METROPOLITAN WATER DISTRICT OF SOUTHERN CALIFORNIA

**99-AFC-8C**

**Re: Notice of Insignificant Project Change, Blythe Energy Project Transmission Line (BEPTL) Modifications; Docket No. 99-AFC-8C.**

3. Figure 2-7, page 18:

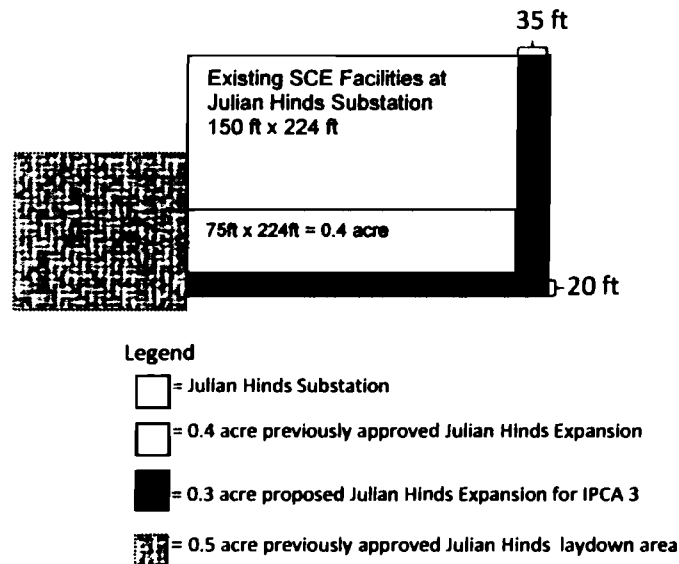
Please modify the drawing and legends for clarity similar to the diagram below. The only crosshatched area designating the laydown area is in the smaller left side rectangle as shown below. There should be no laydown area and no crosshatched area within the larger box to the right in Figure 2-7. It is Metropolitan's understanding that the new 0.3 acre of additional substation expansion is to be a strip of land 35 ft to the east of the existing substation and an additional 20 ft to the south of the 0.4 acres of expansion previously approved and described on page 3-4 of the CEC Revised Environmental Assessment dated September 2006. Also, please replace “Hines” with “Hinds” in the lower right hand corner of this figure.
